Project	IEEE 802.16 Broadband Wireless Access Working Group < http://ieee802.org/16 >	
Title	Consistent MAC Header Extendibility Mechanisms	
Date Submitted	2005-03-17	
Source(s)	16e session#36 MAC Header Drafting Group	Voice: 760-448-4168 Fax: 760-448-1989 lwang@cygnuscom.com
Re:	This contribution proposes additional capabilities for 802.16e	
Abstract	[Description of document contents.]	
Purpose	The purpose of this contribution is to define flexible extension mechanism for MAC sub header	
Notice	This document has been prepared to assist IEEE 802.16. It is offered as a basis for discussion and is not binding on the contributing individual(s) or organization(s). The material in this document is subject to change in form and content after further study. The contributor(s) reserve(s) the right to add, amend or withdraw material contained herein.	
Release	The contributor grants a free, irrevocable license to the IEEE to incorporate material contained in this contribution, and any modifications thereof, in the creation of an IEEE Standards publication; to copyright in the IEEE's name any IEEE Standards publication even though it may include portions of this contribution; and at the IEEE'

Figure XXa: Format of Extended header

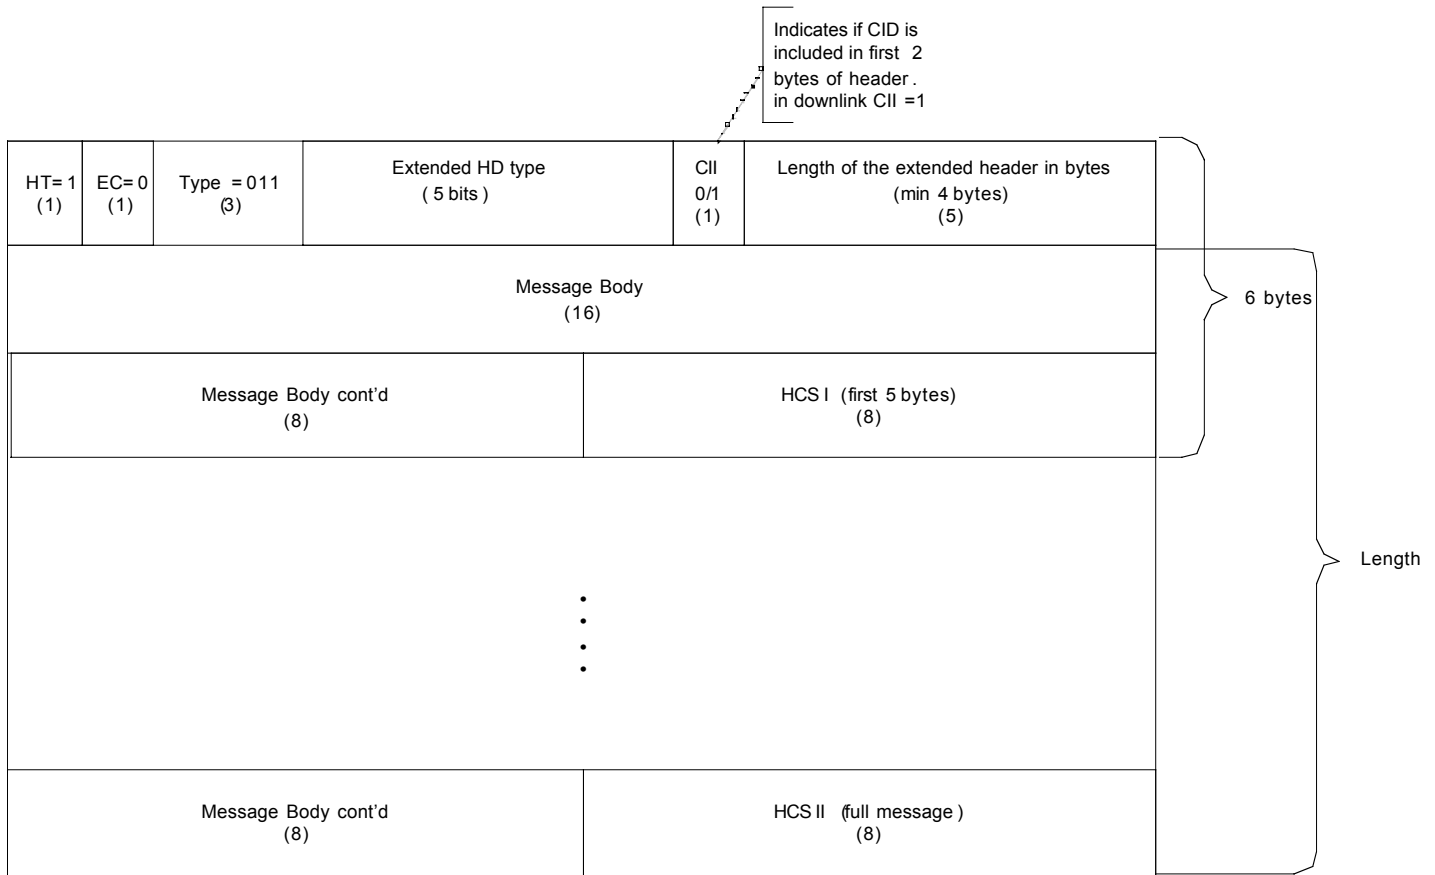
1. Page 26, line 40, insert the following:

6.3.2.1.7 Extended MAC Header

The format of Extended MAC Header is shown in figure x1.

The Extended MAC header shall have the following properties:

- a) The size of the Extended MAC header message shall be defined by the field of Length of the extended header.
- b) The EC field shall be set to 0, indicating no encryption.
- c) The CII field (CID Inclusion Indication) shall be set to 1 for the header with CID field and set to 0 for the header without CID field.
